CITY OF ALBUQUERQUE

April 24, 2015

**RE: Main Event, Pan American Freeway and Vassar Drive
Grading Plan and Drainage Plan
Engineer's Stamp Date 3-27-2015 (File: G16-D149)**

Based upon the information provided in your submittal received 4-01-15, the above referenced Grading Plan cannot be approved for Building Permit until the following comments are addressed:

| | DRAINAGE PLAN | DATE 02/26/15 |

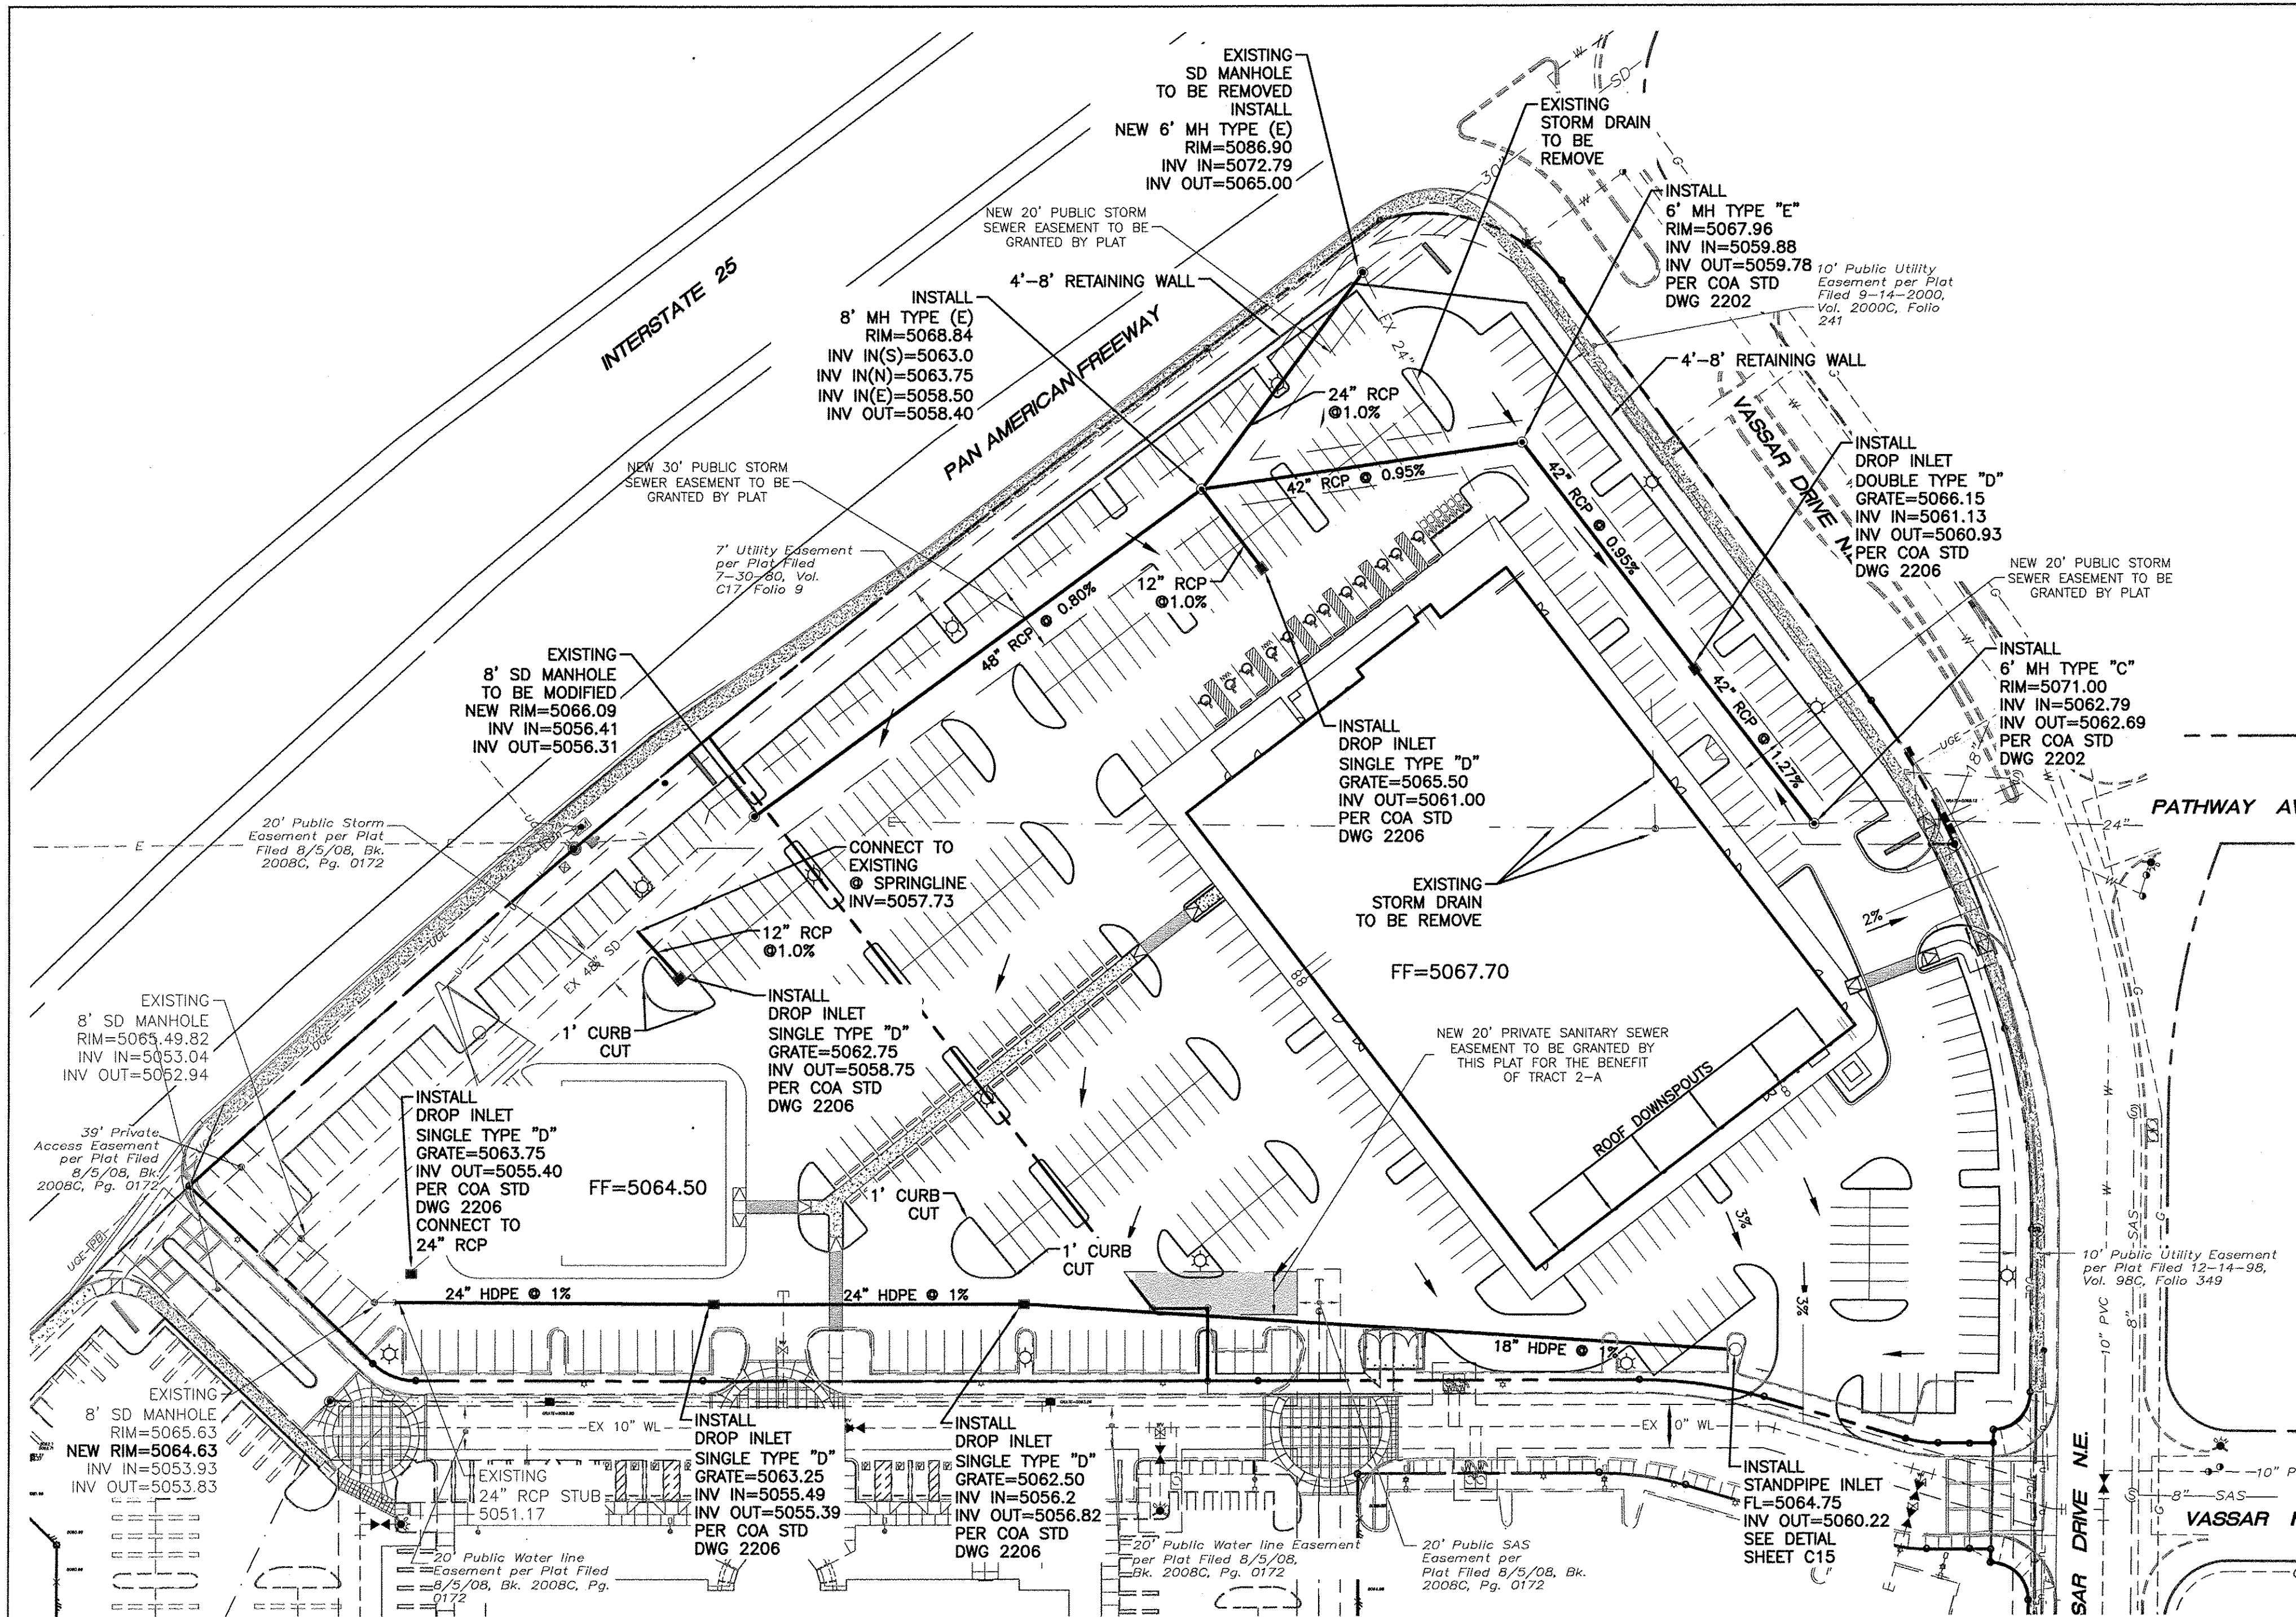
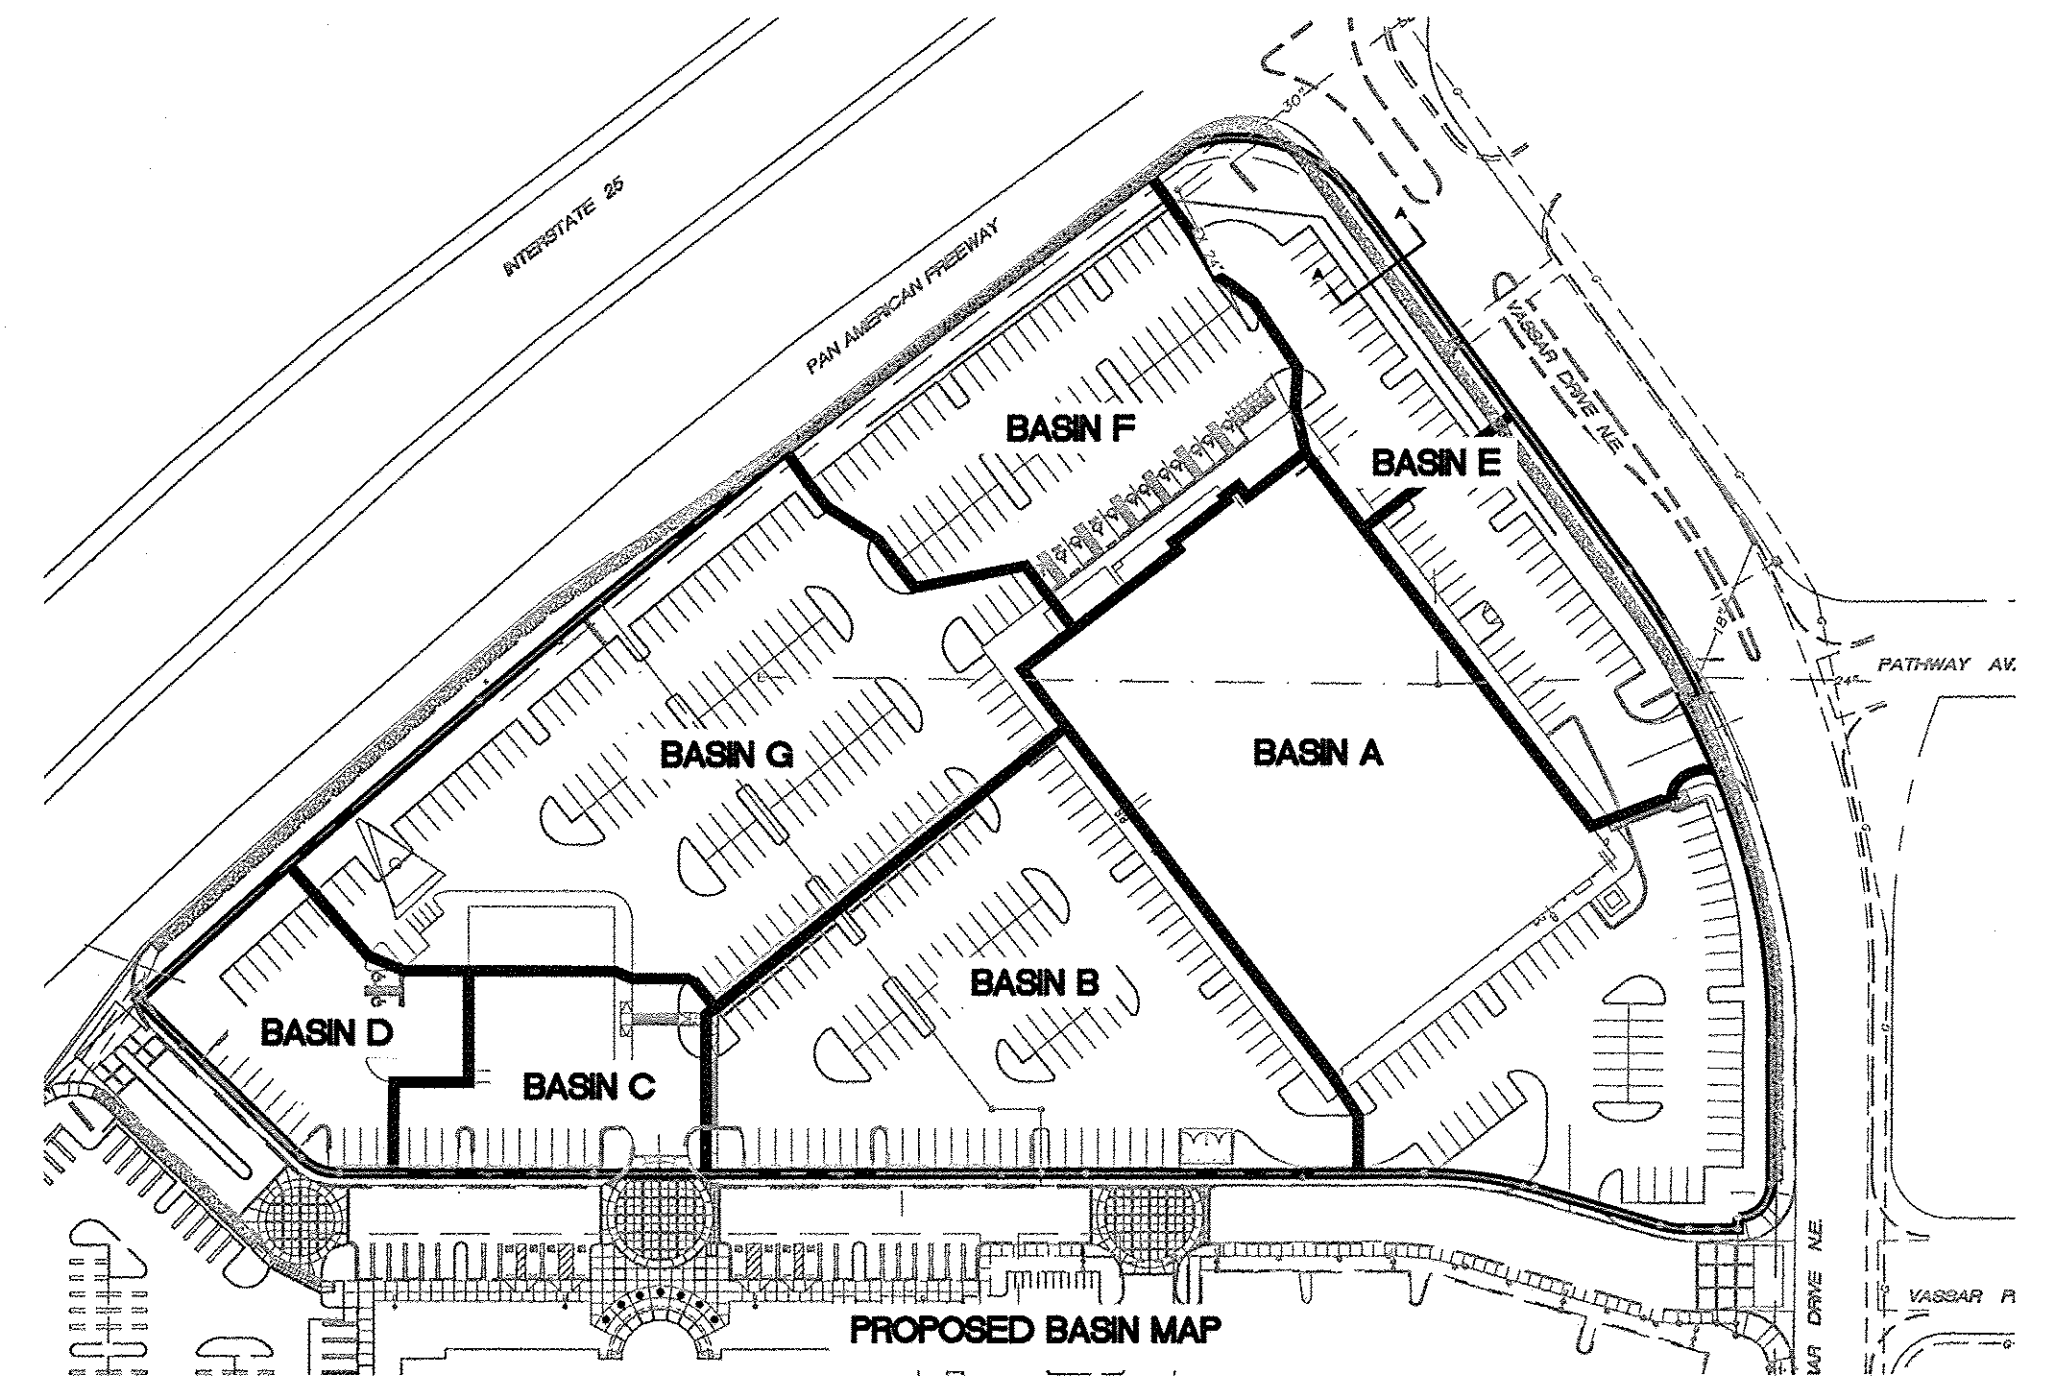
- 3) On the "Drainage Plan", include map of all off-site basins. Label flow on the plan view for each of the new pipes that corresponds with the "Pipe Capacity Table". Label the existing storm drains sizes discharging to the site from off-site as well as the flows that are being conveyed from off-site. Show existing 48" pipe downstream of site along with capacity and total proposed discharge from on-site.

8) Call for existing 24" stub to be removed on Drainage Plan on the southwest corner of the site.
